STAFF REVIEW AND RECOMMENDATIONS
PUBLIC HEARING
March 5, 2025

ABBREVIATED PLAT: GARLEY No. 2
LEGAL DESCRIPTION: SEC 09, T17N, R02E, SEWARD MERIDIAN AK
PETITIONERS: JOSEPH DAUGHERTY
SURVEYOR/ENGINEER: ALL POINTS NORTH
ACRES: 1.93 ± PARCELS: 2
REVIEWED BY: MATTHEW GODDARD CASE #: 2025-020

REQUEST: The request is to create two lots from Lot 2, Garley Subdivision, Plat No. 2019-123 to be known as **GARLEY No. 2**, containing 1.93 acres +/- . The property is located south, north, and directly west of E. Outer Springer Loop, and east of S. Caulkins Street; within the SE ¼ Section 09, Township 17 North, Range 02 East, Seward Meridian, Alaska. In the Greater Palmer Community Council and in Assembly District #2.

PRELIMINARY
PLAT OF

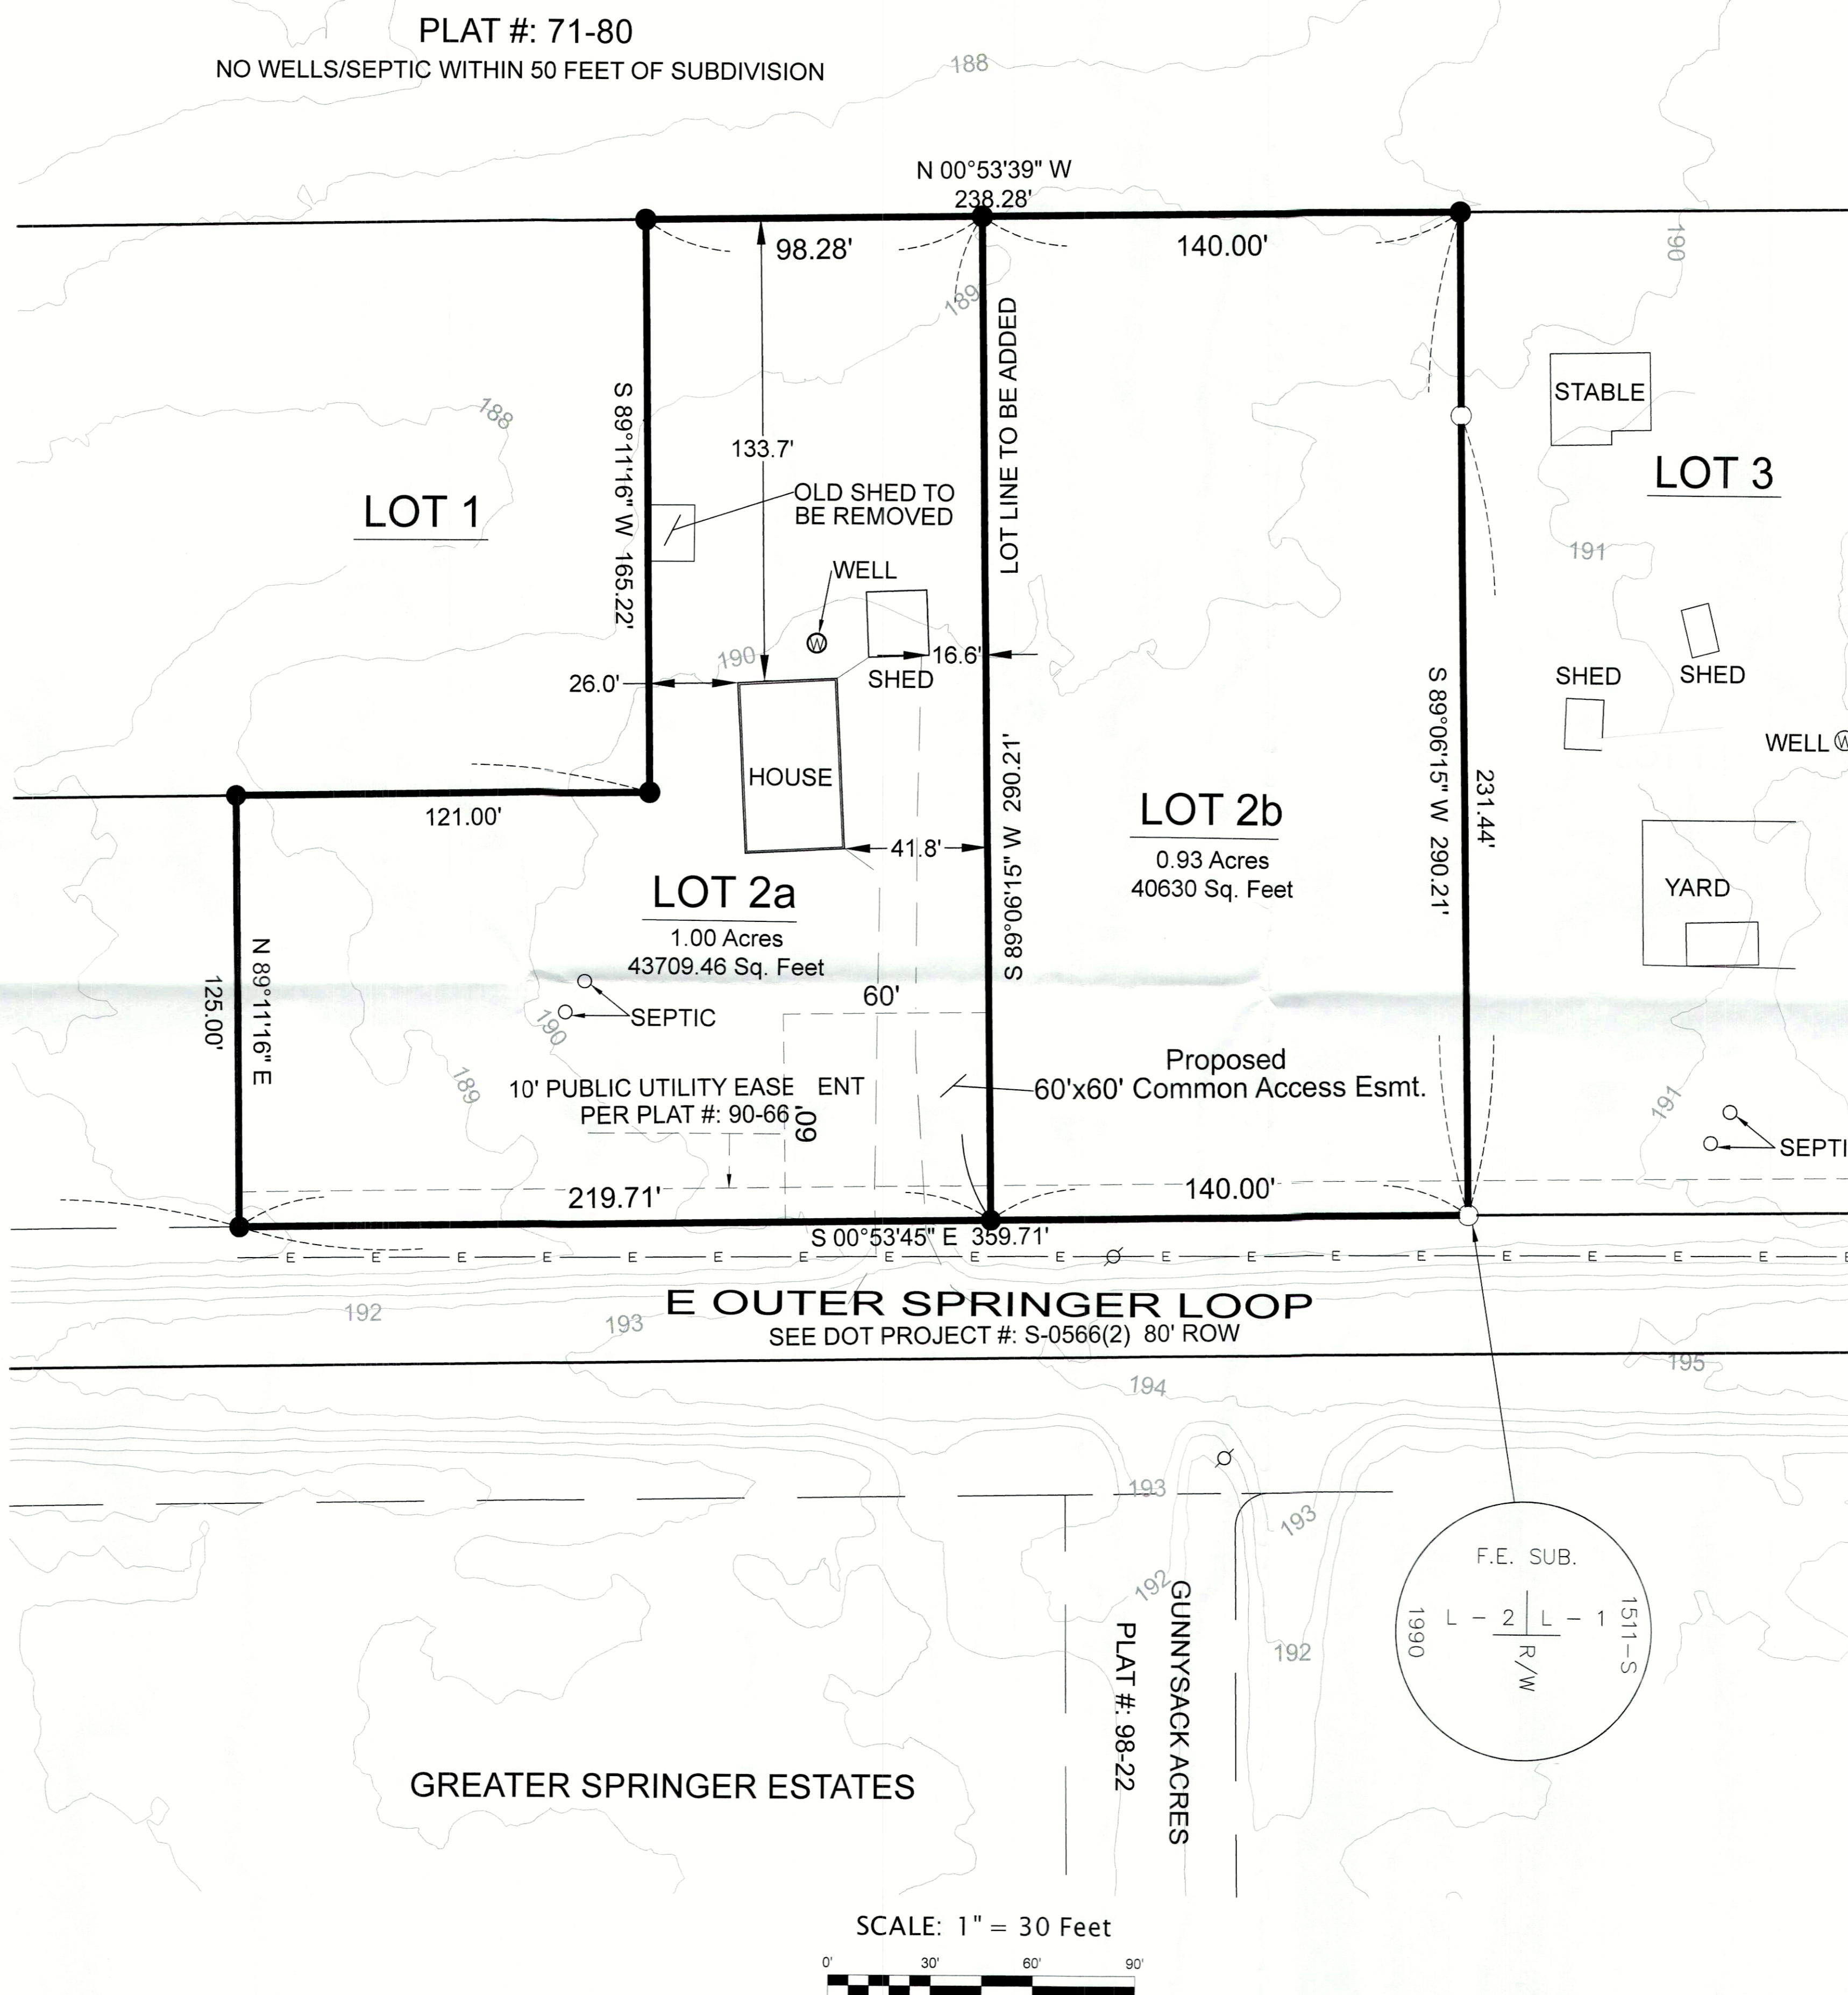
DISCUSSION: The proposed subdivision is creating two lots. Access for both proposed lots is from E. Outer Springer Loop, a State of Alaska owned and maintained road. A 60' X 60' common access easement is being proposed to serve as shared access onto E. Outer Springer Loop. There is a shed on the southern boundary of proposed Lot 2A that will need to be removed/relocated prior to recordation (**Recommendation #4**).

- ADOT&PF will permit a single shared access to Outer Springer Loop Road. A shared common access easement is required.
- The word proposed will need to be removed from the proposed 60'X60' Common Access Easement on the final agenda plat. *Platting staff notes that this will be resolved during the final review process.*

- **WC 12 Walker; Resolute; Plat #2018-113 (Willow Fishhook Road)**
 - No Objection to the proposed lot subdivision.
 - Subsequent development will require permitting onto Willow Fishhook Road.
- **Garley No 2; PA 12 Daugherty; All Points North LLC; Plat #2019-123 (Outer Springer Loop Road)**
 - DOT&PF will permit a single shared access to Outer Springer Loop Road for both lots. A shared common access easement is required.
 - Remove word "proposed" from "Proposed 60'x60' Common Access Easement" on final agenda plat.
